REQUEST FOR EXCEPTIONS TO PUBLIC ROAD STANDARDS –24 LOTS AND A REMAINDER LOT LOCATED IN THE UNINCORPORATED PORTION OF SAN DIEGO COUNTY WITHIN THE LAKESIDE COMMUNITY PLAN AREA, PDS2014-TM-5582

REQUEST FOR EXCEPTIONS TO PUBLIC ROAD STANDARDS – 24 LOTS AND A REMAINDER LOT LOCATED IN THE LAKESIDE COMMUNITY PLAN AREA, PDS2014-TM-5582

REQUEST FOR AN EXCEPTION TO A ROAD STANDARD –TM 5582

Ref.: Lemon Crest , PDS2014-TM-5582, Design Speed Exception Request

PLAN: LEMON CREST DRIVE
PDS2014-TM-5582

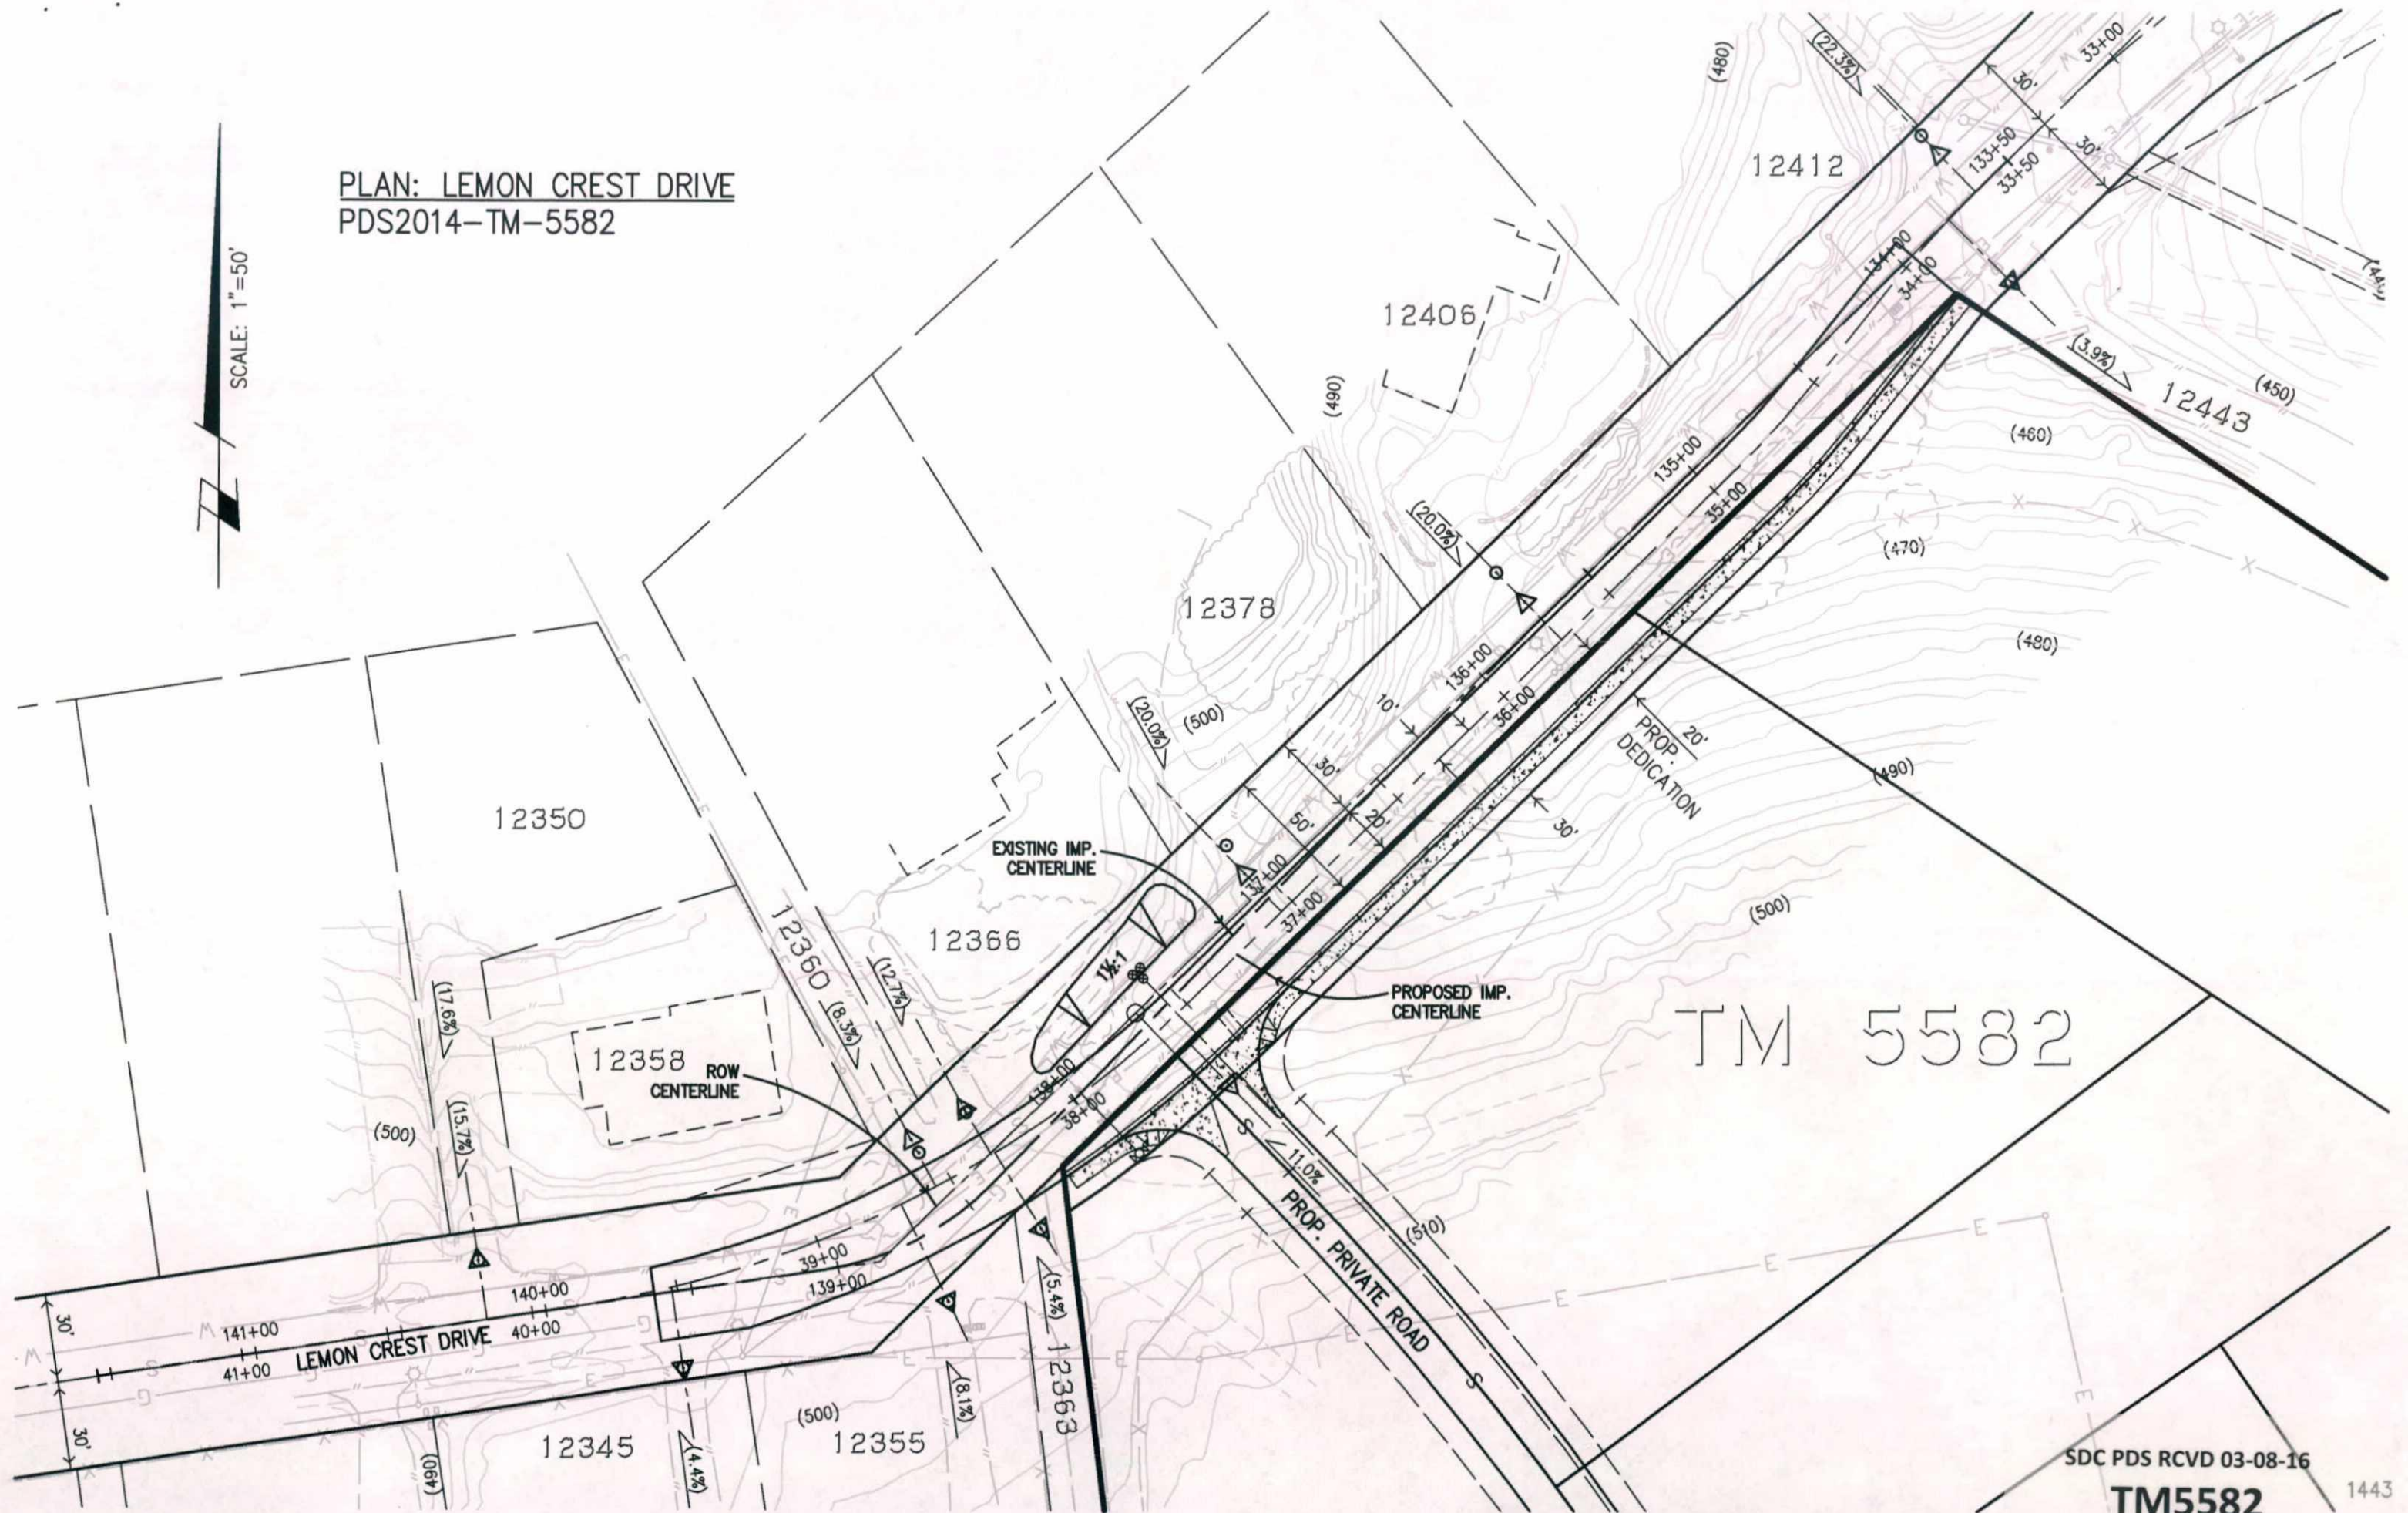
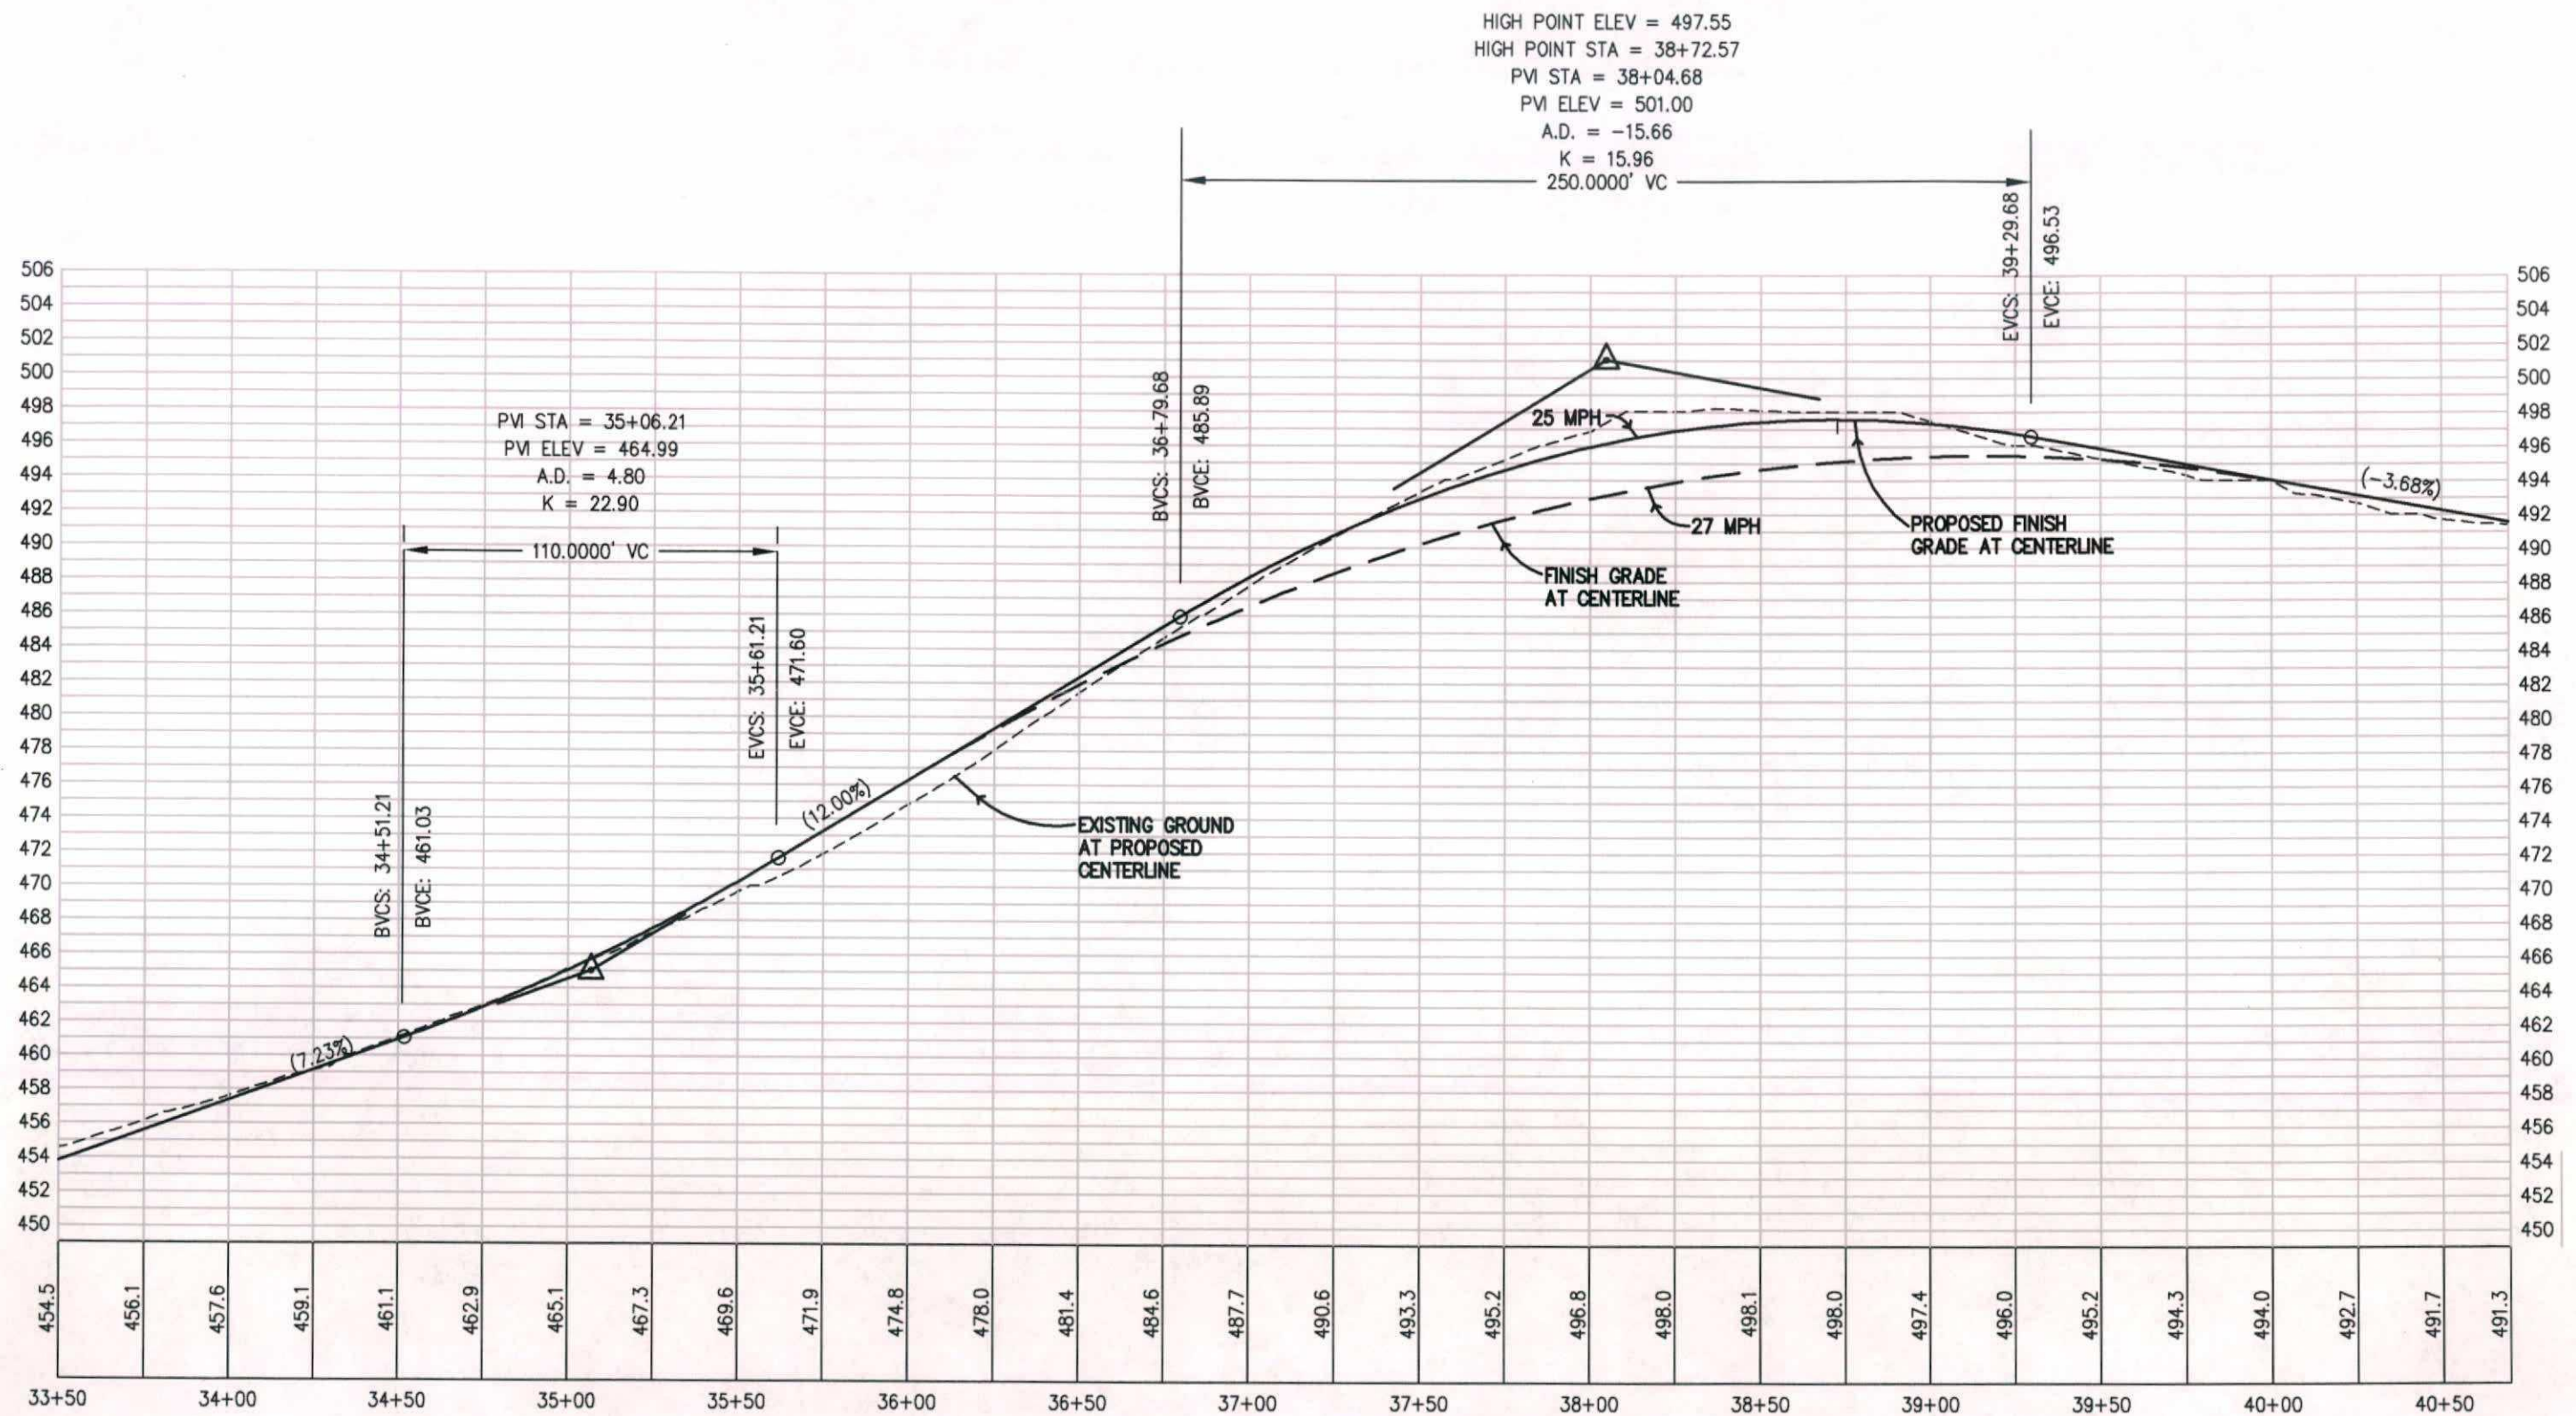
1. An analysis of stopping sight distance along the crest and intersectional sight distance for all affected driveways and the proposed private road needs to be conducted for the proposed 25MPH crest design and a crest design between 25MPH and 30MPH, say 27 MPH. We acknowledge that a 30MPH design may not be practical, but a crest design of roughly 27MPH may work better over a 25MPH crest design from a sight distance and potential road liability perspective.
2. The centerline of the proposed alignment should coincide closely with the centerline of the road. Deviating significantly from the right-of-way centerline creates roadway geometries that may be challenging to future road improvement projects.

The proposed plan does not adhere to the project's conditions for road improvement widths for Lemoncrest Drive at the project frontage. The conditions call for 20 feet of pavement between the right of way centerline and the face of concrete curb on the project side, and 14 feet of pavement between the right of way centerline and the face of AC dike on the other side, a total width of 34 feet of paved roadway. It is recommended that the requestor apply for a design exception for reduction of the paved shoulders with appropriate justification to accommodate bicyclists and errant motorists. Note that lane widths shall remain a minimum 12 feet in width.

The project proposal is for 28 feet of pavement width along the frontage. It was suggested by staff that an additional 6 feet of paving be added on the north side of this proposed improvement to accommodate a pathway. We are proposing a pcc sidewalk on the project side of the road which serves this subject. An additional pathway (paved) on the opposite side where there are not any shoulders to connect to would not serve this project and appears to have no nexus to the proposal.

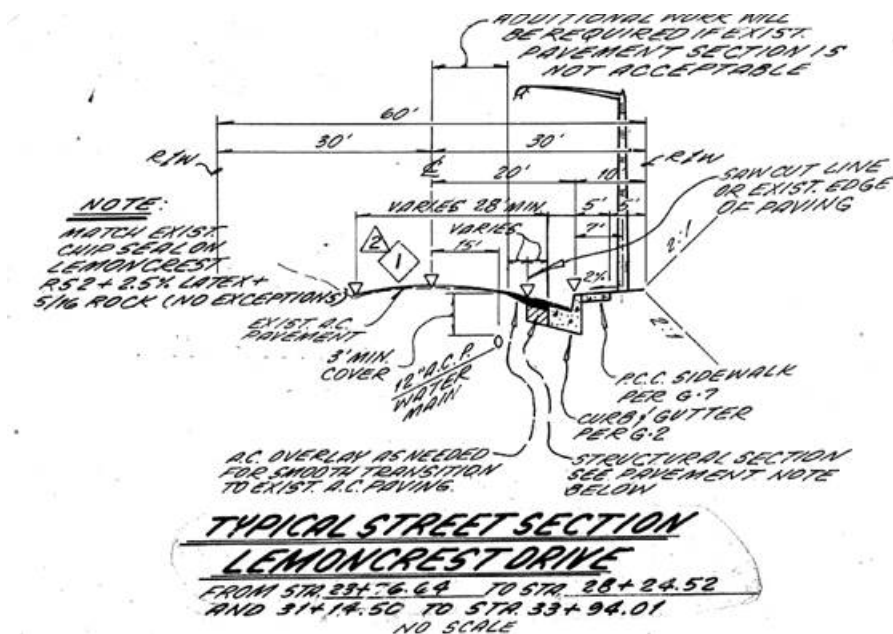
I am sending you, attached, a copy of the curb grade plan against which the County issued a public improvement permit when the elementary school at our easterly edge built the partial improvements of LemonCrest Drive. Please note it is a record plan, the improvements exist right up to the northeast corner of this

project. Their typical cross section is looking in the direction of the school (easterly). Our project is not a spot improvement, we will have to match this condition. To build a crown in the middle of a partial improvement would be inconsistent with what you made the school build. Please pass this information on to Ed Sinsay and your traffic personnel for consideration. You have the full record plan in your cartographic services records if they desire to see it.

I have a meeting with Zoubir regarding the DER for Lemon Crest project and he agreed that required improvements for this TM can match the record plans CG 3548. Based on the typical cross section shown below, the proposed face of curb on your project side will be located 20' from CL and the required pavement width will be a minimum of 28' with approximately 18.5' on your project side and about 9.5' on the opposite side. I will revise the DER letter to reflect this.
